COMBUSTION ENGINEERING, INC.

Enclosure 1-NP to LD-83-031

Response to NRC Questions Regarding  
System 80<sup>TM</sup> CPC/RPCS

April, 1983

Figure 1

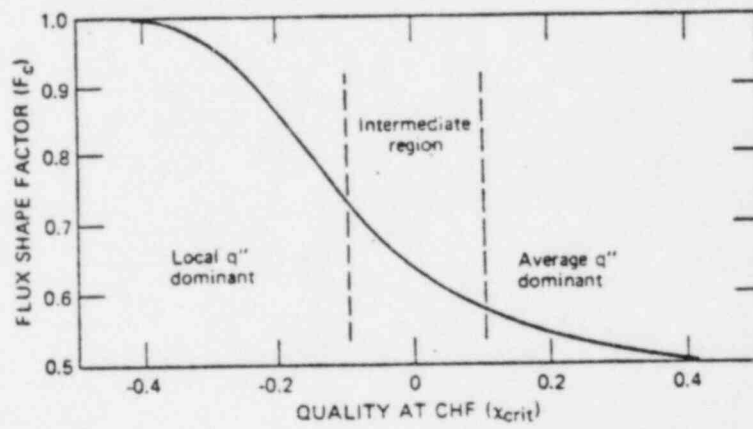
The CPC change No. 4 modifies the calculation of the transient non-uniform heating correction F-factor  $F_k$ , by updating the  $F_k$  based on the direction of the change in quality margin. Explain what the coefficients QLCOF1 and QLCOF2 are and describe how they are calculated. Also describe how the expression for updating  $F_k$  from the static F- factor is derived.

representative behavior of the F-factor as a function of quality can be seen from Figure - 1 (Reference 11.1). [

The new expression follows the trends of the F-factor more accurately and therefore provides a more accurate assessment of the updated DNBR than the previous expressions. This results in increased operating margin.
